# County of Fairfax, Virginia

## STAFF REPORT

APPLICATION PRC A-502-02  
WAIVER #15797-WPFM-001-1

**PROPOSAL:** The applicant seeks PRC Plan approval to redevelop eighteen (18) existing 3-story apartment buildings containing 348 multifamily units with four (4) multifamily buildings and sixty-nine (69) single-family attached units for a total of 951 residential units.

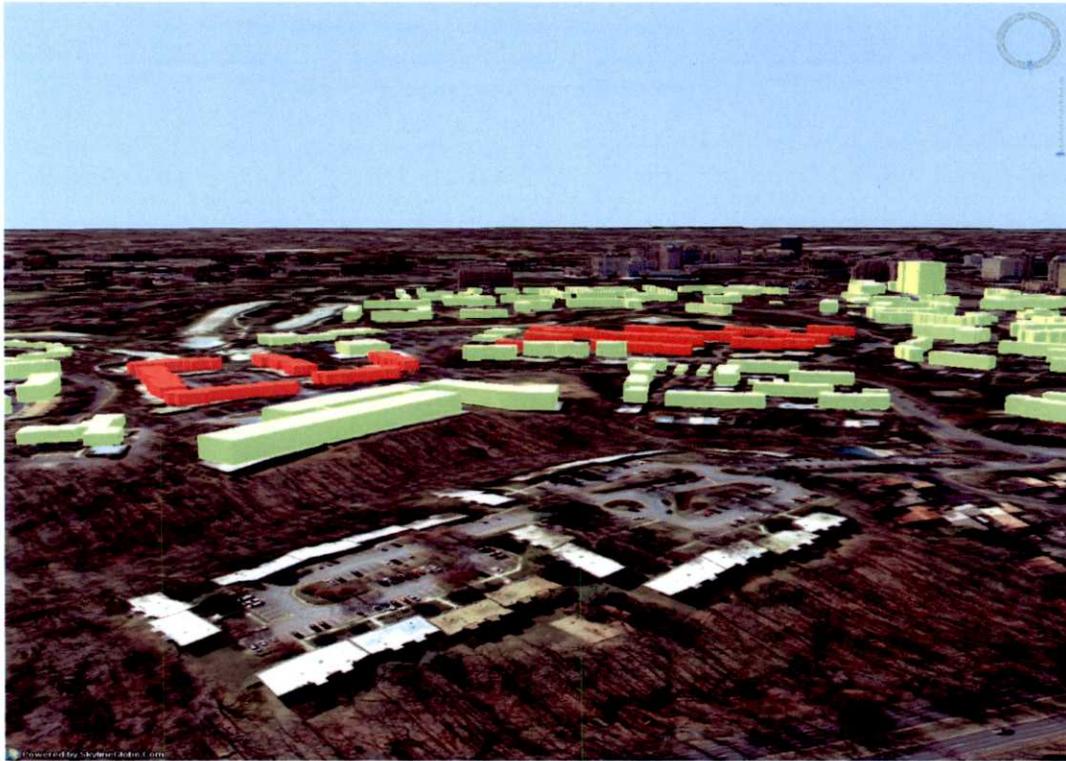
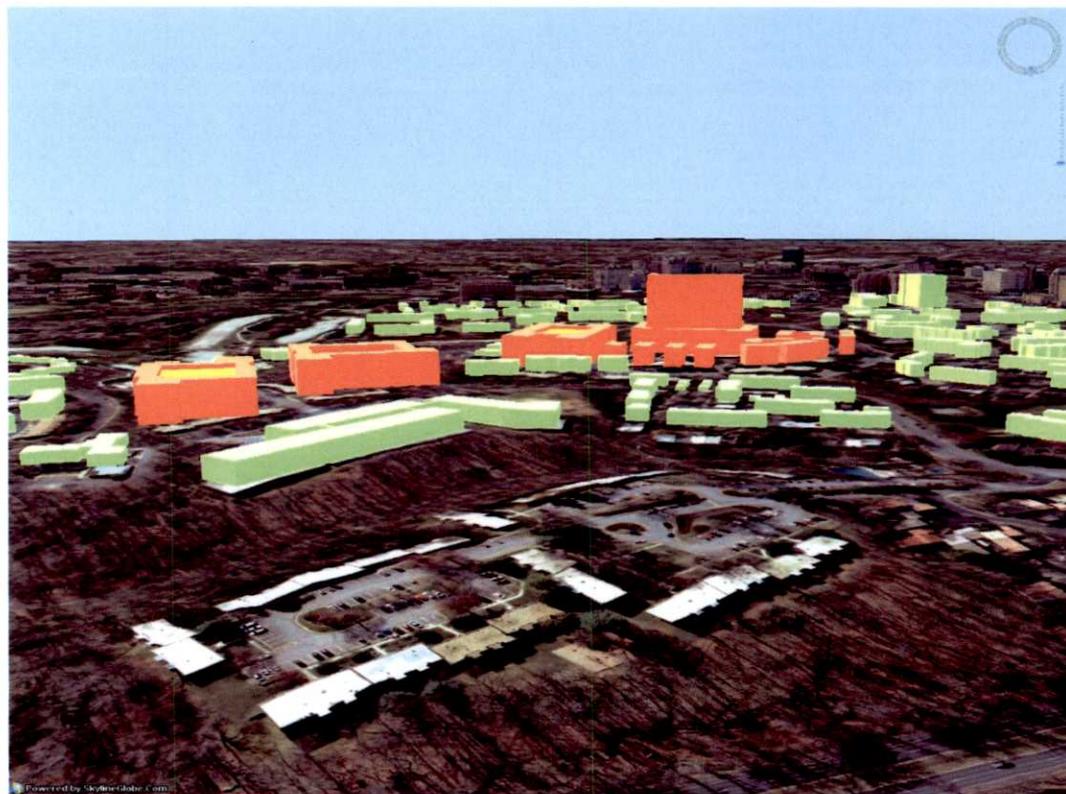
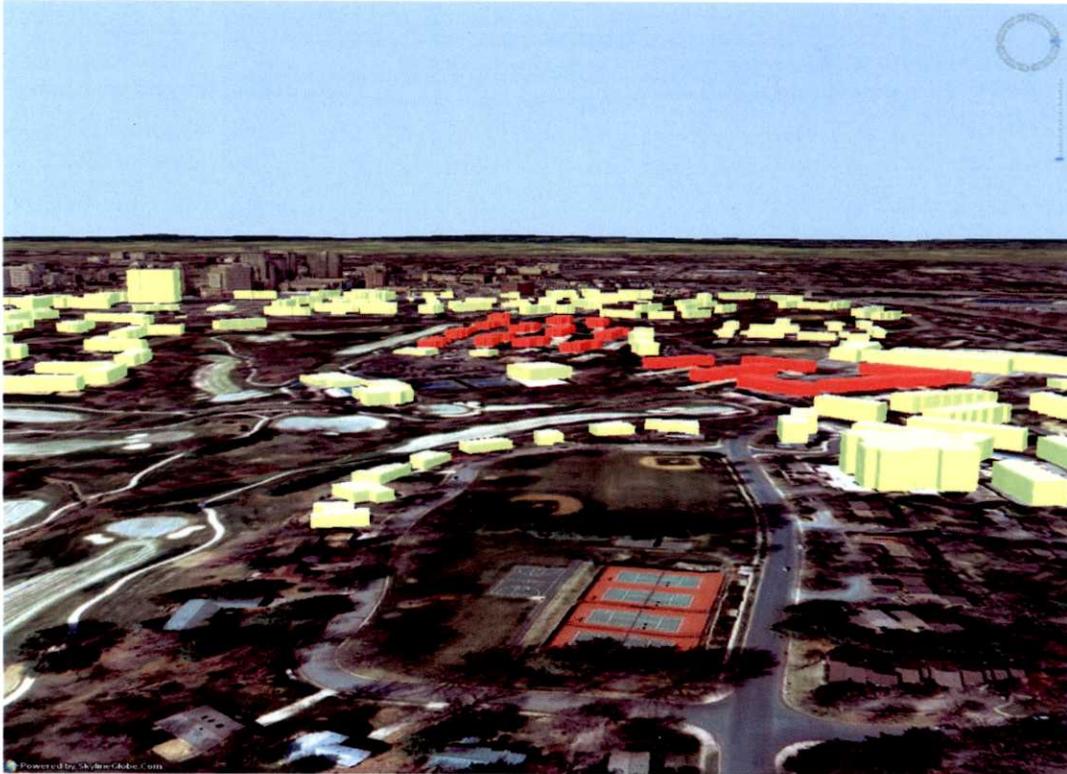
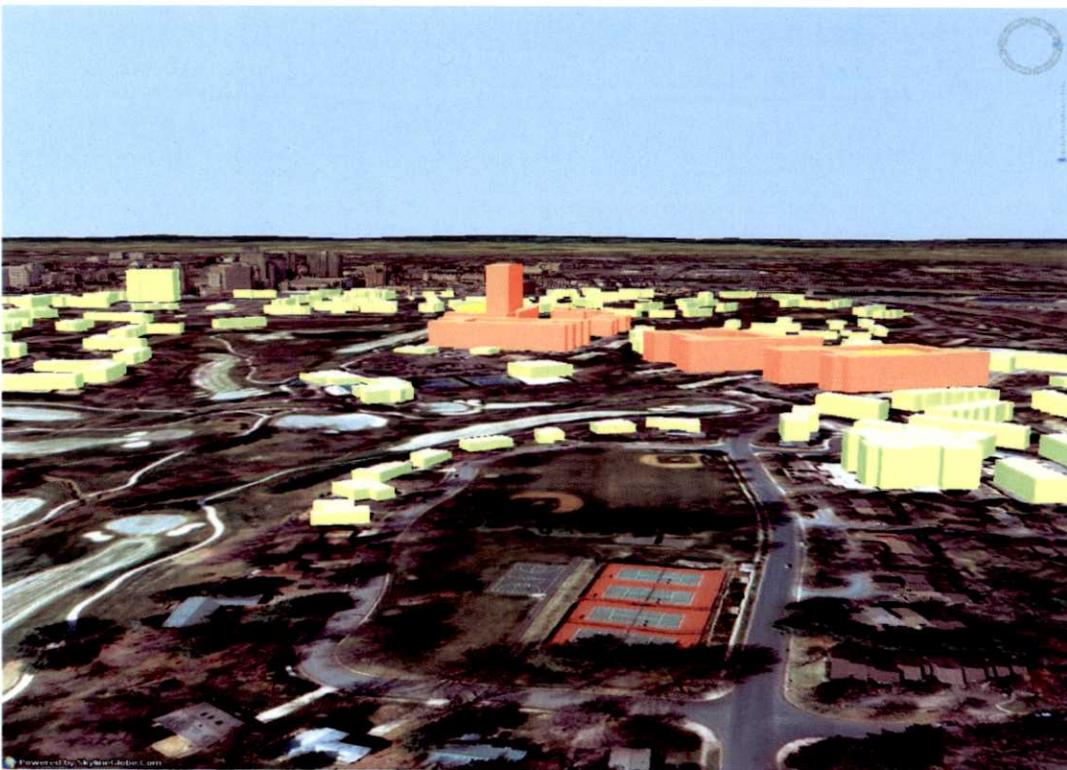
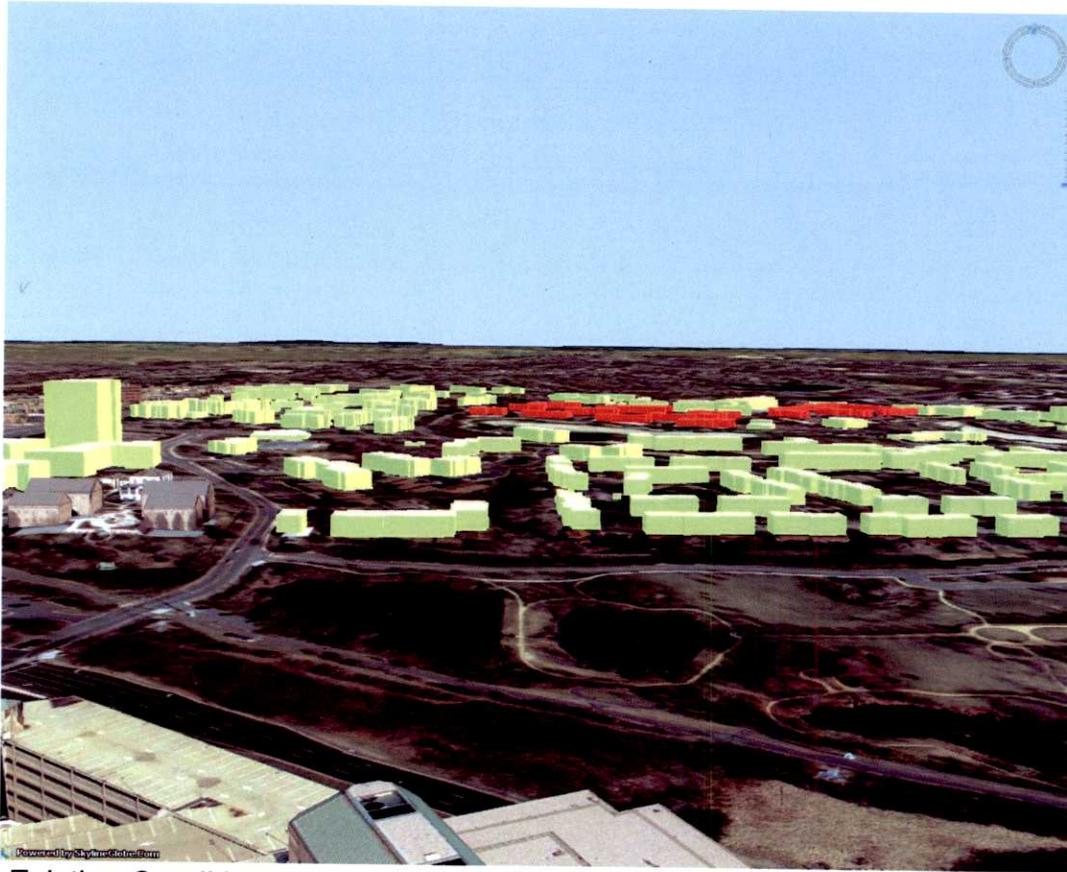
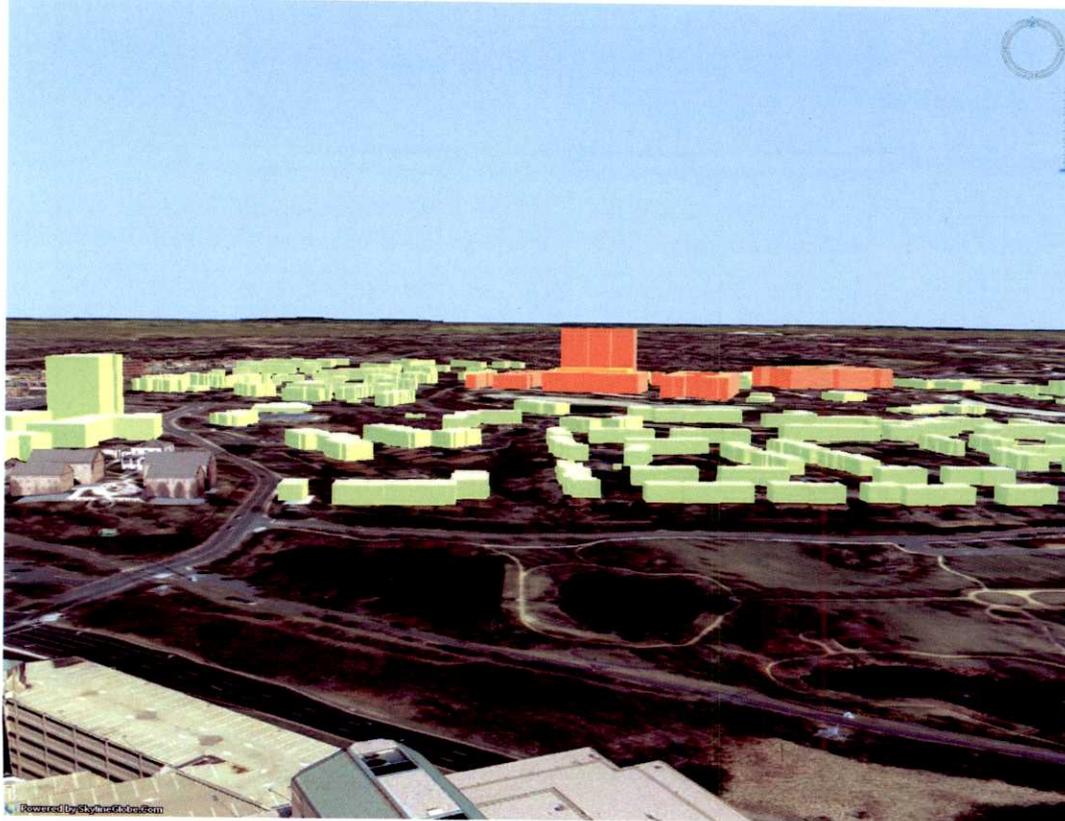
In staff's opinion, these illustrations show that the proposed development will dwarf and overwhelm the surrounding neighborhood. Staff does not believe that the resulting impact is appropriate given the Plan language. While staff recognizes that the areas designated for high-density residential can achieve between 20 du/ac to up to 50 du/ac, staff does not believe that development at the high end of the density range as proposed with this PRC Plan should be achieved on the subject site due to the significant change in character and resulting impacts on the surrounding development. Further, in the statement of justification (contained in Appendix 1), the applicant writes that *"the revitalization of the existing properties into a residential nucleus can serve as a development node to define and strengthen the corridor between Reston Town Center and Reston Lake Anne Village."* However, the subject site is not a designated development node. Rather, it is a transition area between the designated Reston Town Center Town and Lake Anne Village Center. Staff believes that it is inappropriate for the applicant to propose in effect a revision to the Plan to create its own "center" through a PRC Plan. If the applicant believes that the Plan for Reston should be modified, the proposal should have been preceded with an amendment to the Plan, which would be considered by the community, the Planning Commission and the Board of Supervisors in a broader context than an incremental and "spot" development request which is not in keeping with the Plan.
